Project: IEEE P802.15 Study Group for Wireless Personal Area Networks (WPANs)

- Submission Title:** PSSS proposal – Parallel reuse of 2.4 GHz PHY for the sub-1-GHz bands
- Date Submitted:** 2nd May 2005
- Source:** Andreas Wolf, DWA Wireless GmbH and Hans van Leeuwen, Integration
DWA Wireless GmbH, Germany
Tel.: +49 (0)700 965 32 637 aw@dw-a.com

- Abstract:** Ballot comments received indicated interest in the TG4b task group to modify the PSSS mode for 868 MHz to have the same 250 kbit/s bitrate as the 2.4 GHz and the PSSS 915 Mhz modes. Offering also simpler preamble.

Highlights of Proposed Changes

No modification of the basic PSSS model: PSSS 250-400 868 MHz – BPSK/ASK (20/32 bit/s/Hz)

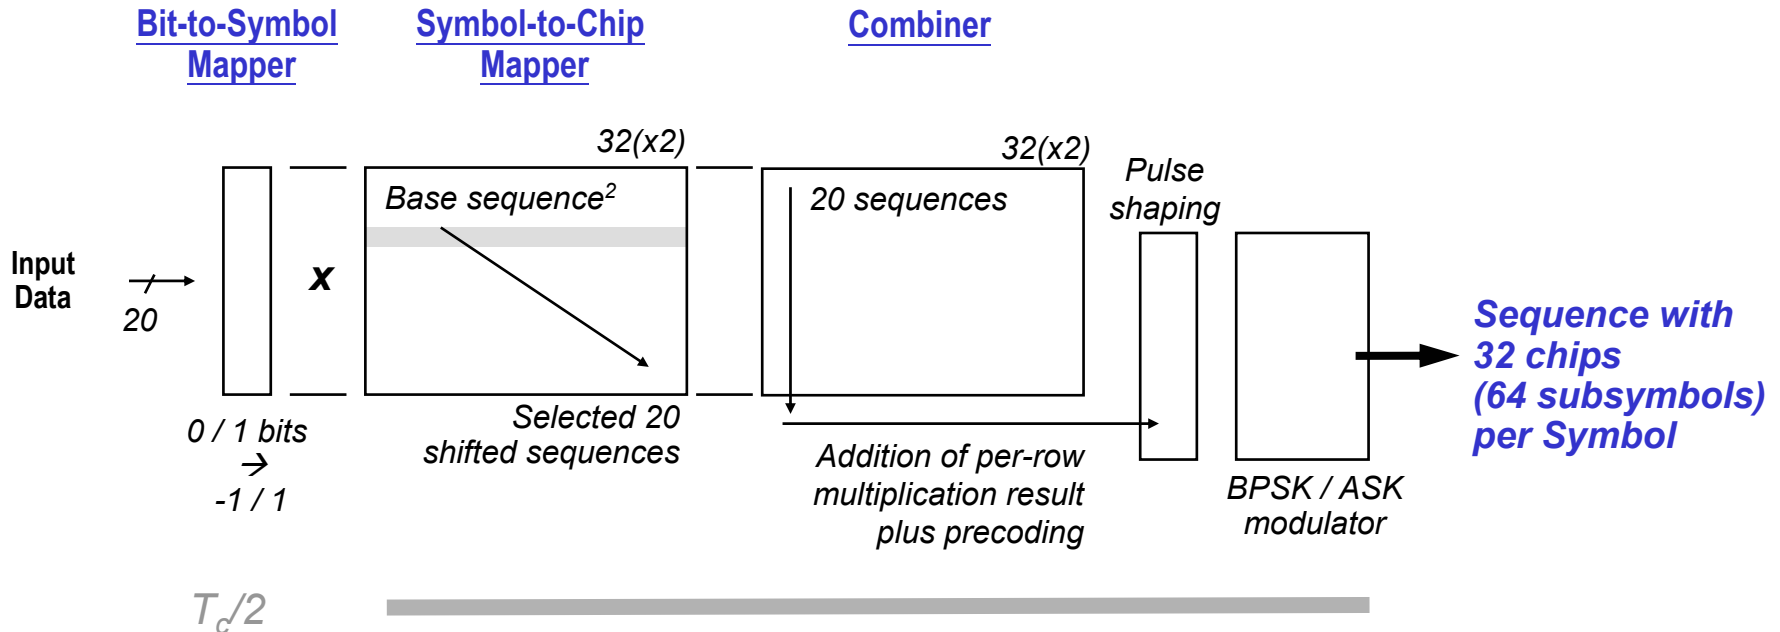
- 2 sub-chips per chip – basic chip rate of coding scheme is unchanged
- Addition per sub-chip for multivalue encoding – no other changes of PSSS model

- **No increase of Tx complexity in real-world implementation –**
 - Oversampling used for baseband filtering to achieve PSD compliance anyhow
 - No change in number of chips per symbol – no increase in coding table sizes
- **Simpler baseband filter sufficient due to lower chiprate, see PSD at Appendix.**
- **No change in Rx processing required**
- **Similar performance, see Appendix.**

Figure 22—Modulation and spreading functions

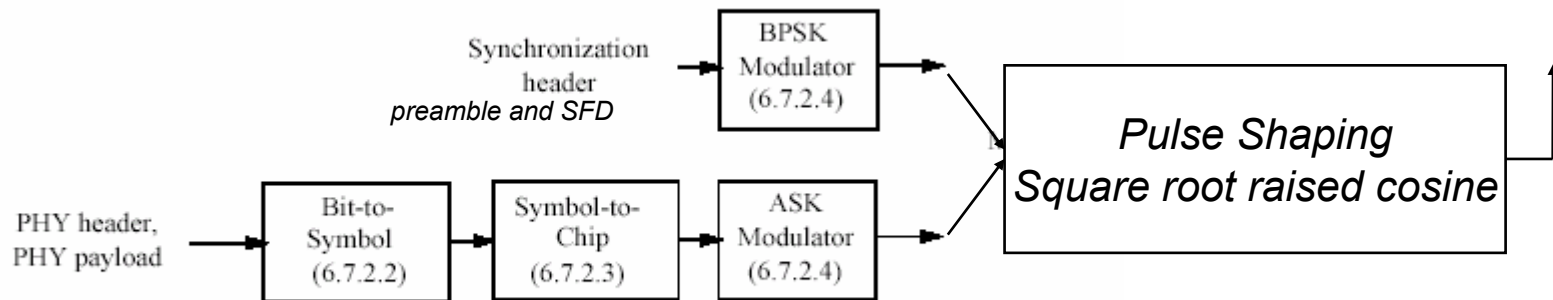
- The preamble (eight times repeated c_0) and the SFD (one time inverted c_0), are BPSK modulated.
- The Phy header and PHY payload are PSSS encoded and ASK modulated.
- Both signals have same chip duration and passes same pulse shaping.

Comparision Actual/New Proposed Preamble Length of Proposed Preamble

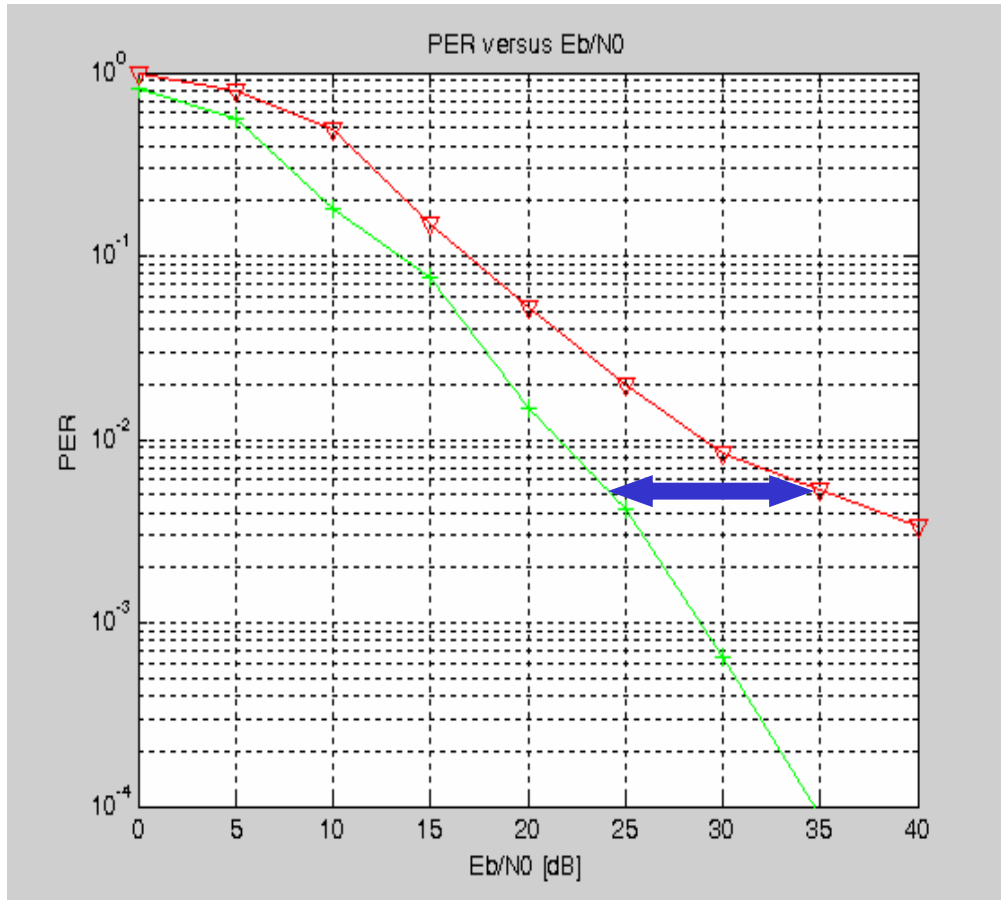
- The Sequence 0 is repeated 8/16 times for 868/915 MHz.

PER Performance PSSS 250-400 868 MHz (BPSK/ASK) – Discrete Exponential Channel, 250ns RMS Delay Spread

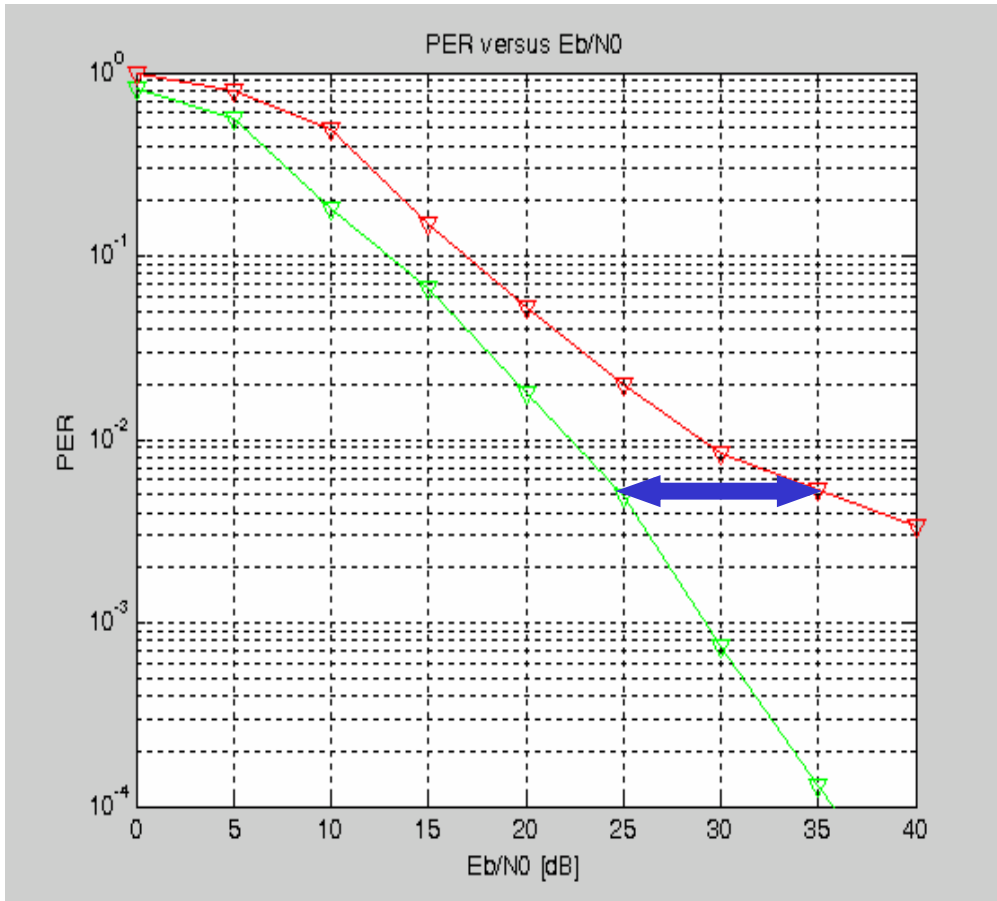
Comparison to PSSS 206-440 868 MHz

- No visible degradation of performance

PSD for PSSS 250-400 868 MHz (in 600 KHz channel) Baseband pulse shaping non-linear “Real World PA”

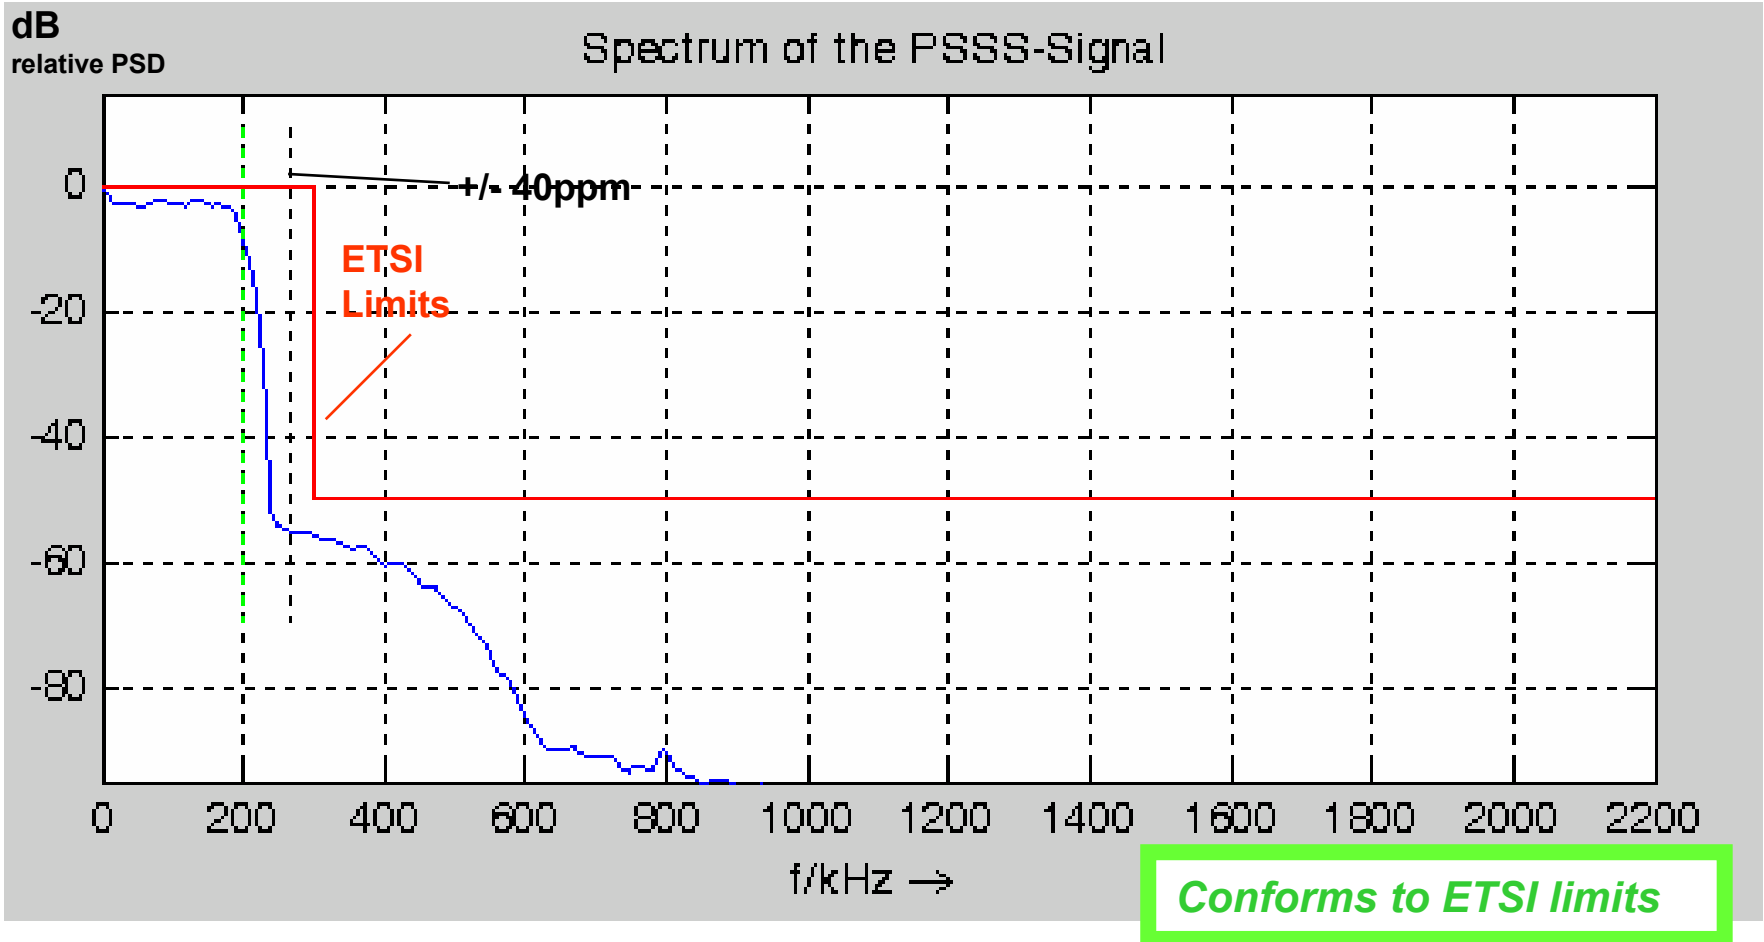
Simulations of the relative PSD in dB for the PSSS 250-400 signal: With precoding, at 400 kchip/s, 250 kbit/s, +/- 40ppm, 50% PA drive, square root raised cosine filter with $r = 0.2$

Preamble Detection with current Barker Code

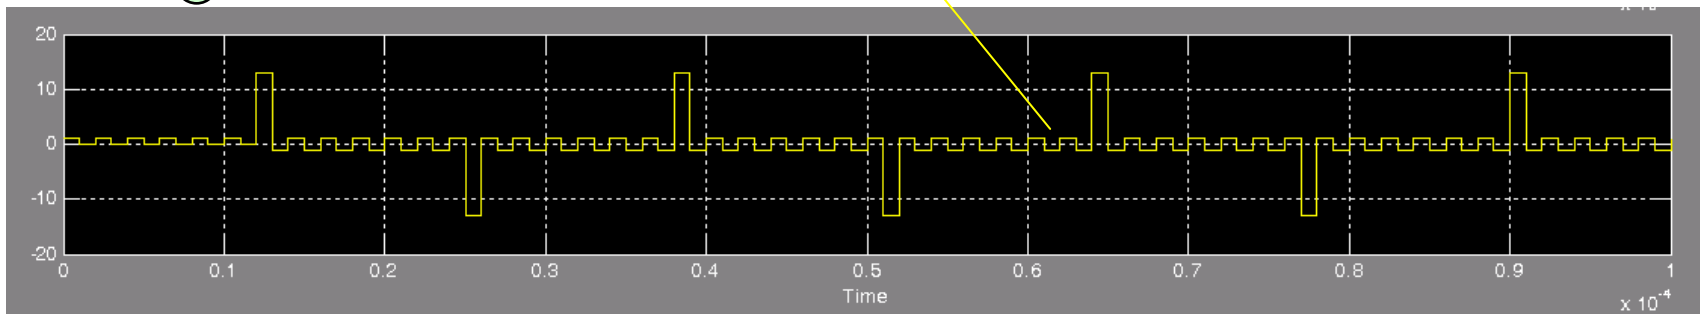
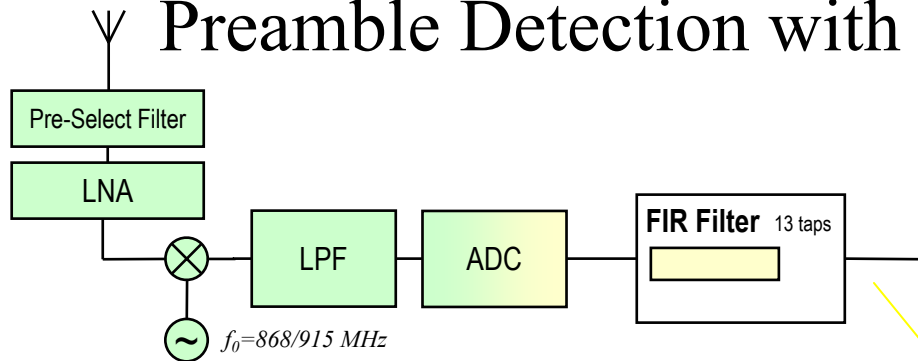
- When detecting the current barker code based preamble with FIR filter, the signal coming out of the FIR filter has side slopes limited to +/- 1.
- Advantages:
 - DC free
- Disadvantages:
 - **Two FIR filters needed**, one for preamble detection (13 chip barker code), one for PSSS decoding (31 chip m-sequence).
 - **Not multiple of symbol duration**

Preamble Detection with Sequence 0 of the PSSS Coding Table as preamble

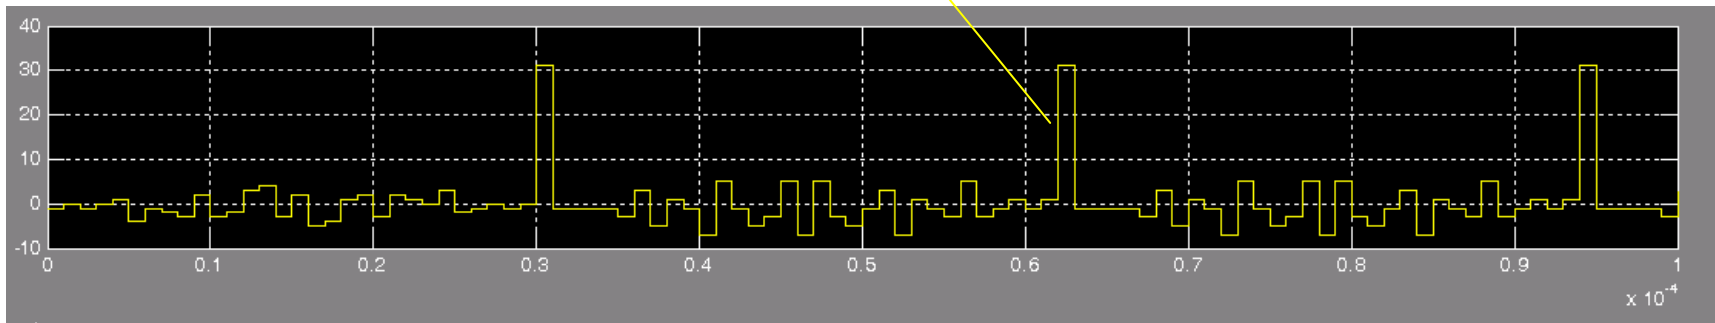
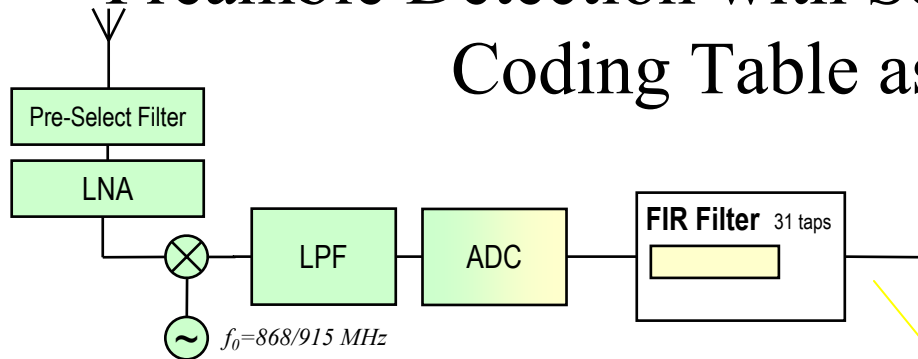
- When detecting the preamble, based on repeated sequence 0 with FIR filter, the signal coming out of the FIR filter has side slopes limited to $+5/-6$.
- Advantages:
 - Use of just one FIR filter or correlator for preamble detection and PSSS decoding.
 - **32 chip long preamble code.= multiple of symbol duration and similar to other phys.**
 - DC free
